AGENDA DESIGN ADVISORY PANEL MEETING

- 4. PRESENTATIONS:
 - a. Development Permit Application No. DP1087 1875 and 1885 Boxwood Road

STAFF DESIGN COMMENT

DEVELOPMENT PERMIT NO. 001087 - 1875 BOXWOOD ROAD

LANDSCAPE CONCEPT PLAN

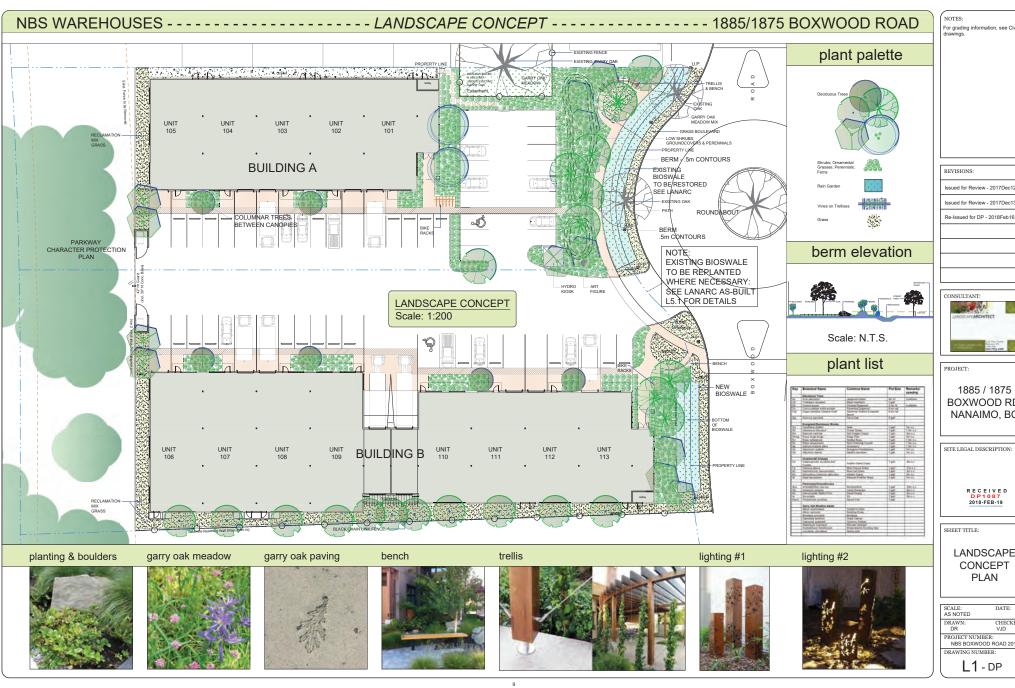
The landscape plan in front of Building B is weak as the 90-degree parking is very visible to the street. It is important to create a landscape plan that also shields the vehicle headlights so they do not shine into the road area (roundabout). The applicant proposes to address this challenge with a revised landscape plan to be presented at the DAP meeting.

The landscape plan needs to consider design strategies to reduce the visual impact of the parking court in between the street and Building A, and to address off-site glare from headlights.
